STAFF RECOMMENDATION

2219 White Avenue

April 18, 2018

Application: New construction - infill

2219 WHITE AVE
 FRONT + REAR ELEVATION
 0' 4' 8' 16'

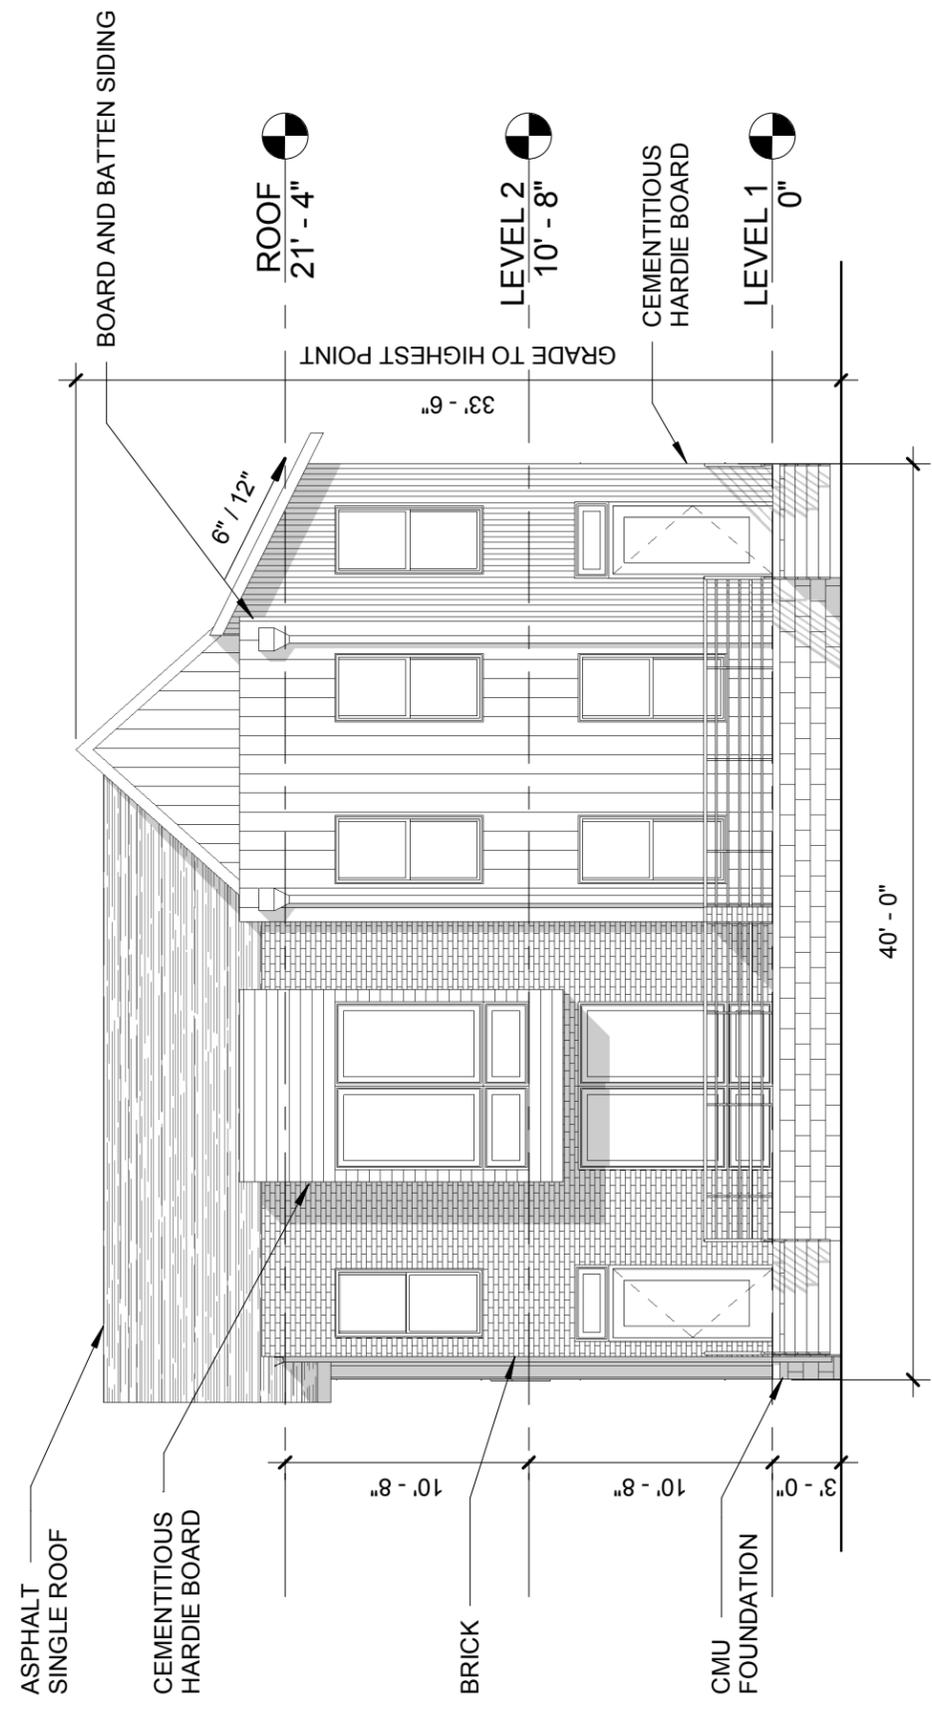
Analysis and Findings: The request is to construct a two-story duplex infill. The lot appears to have a slight cross slope along the front of the property. Staff recommends that the front elevation reflect this prior to issuance of the preservation permit.

The plans do not appear to incorporate four to six inch (4”-6”) mullions between paired windows, four inch (4”) (nominal) casings around doors and windows, or four inch (4”) corner-boards at the face of each exposed corner. Staff recommends that these elements be included as conditions of approval and also that staff approve the materials of the masonry, roof color, trim, porch floors, porch steps, porch posts, railings, windows, doors, driveway, and walkway. With these conditions, staff finds that the project can meet section III.B.2.d.

1. The finished floor height be consistent with the finished floor heights of the adjacent historic houses, to be verified by MHZC staff in the field;
2. A front elevation reflecting the slight cross-slope on the property shall be submitted prior to issuance of the preservation permit;

2219 WHITE AVE
ROOF PLAN

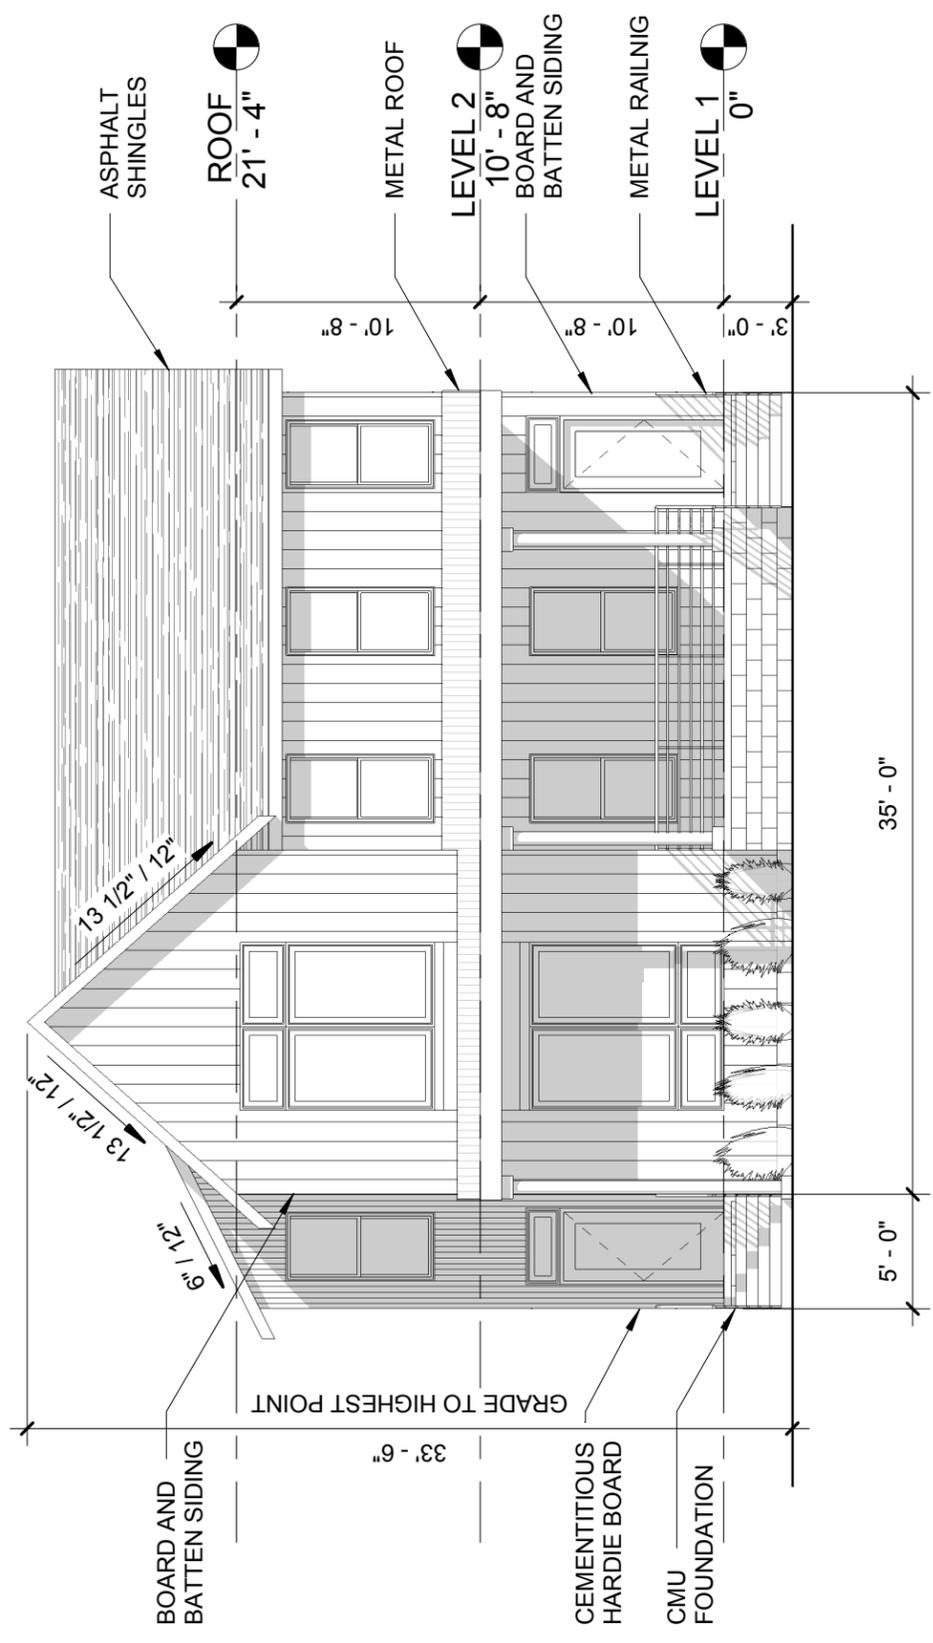
Roof form: The proposed primary roof form is a cross-gable with slopes of 13.5/12 and 7.5/12. The plan incorporates a significant amount of flat roofing with a pitch of 0.5/12 on the rear of the structure. The design guidelines state that “roof pitches should be similar to the pitches found in the district” and that “historic roofs are generally between 6/12 and 12/12.” While the Commission has approved some lower pitches, those cases have usually been for porch roofs or connectors for additions on historic homes, which are smaller areas of flat roofing than proposed with this project. Staff finds that the 0.5/12 proposed roof pitch does not meet Section III.B.e. and recommends that the applicant continue to work with staff so that the infill meets this design guideline. With the condition that the roof form at the rear of the infill meet Section III.B.2.e, staff finds that the proposed roof forms could meet Section III.B.2.e. of the design guidelines.

3. The portion of the porch roof covering the at-grade patio shall be removed;
4. The roof form at the rear of the infill shall meet Section III.B.2.e;
5. An additional window or door opening shall be incorporated on the right side façade near the front;
